# NOTICE OF DECISION

### CLASS 2 SITE PLAN REVIEW

APPLICATION NO.: 25-102028-PLN

**REQUEST:** A Class 2 Site Plan Review for site improvements and expansion of an existing nonprofit shelter, for property approximately .92 acres in size, zoned CR (Retail Commercial), and located at 1875 Fisher Road NE (Marion County Assessor's Map and Tax Lot Number: 072W19BB / 6102).

8 BIKE RACK PLAN

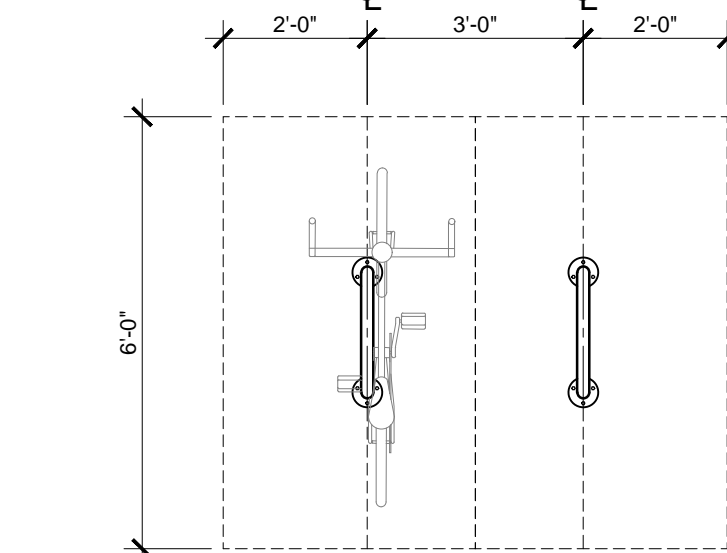
total floor of the development following the addition will be approximately 32,922 square feet. As such, the required amount of bicycle spaces would be nine ( $32,922 / 3,500 = 9.41$ ). The applicant's site plan shows, that five staple racks shall be installed providing 10 bicycle spaces in total. As such, this standard is met.

**Finding:** The applicant has proposed 10 bicycle spaces within 50 feet of the northern entrance of the building. Therefore, this standard is met.
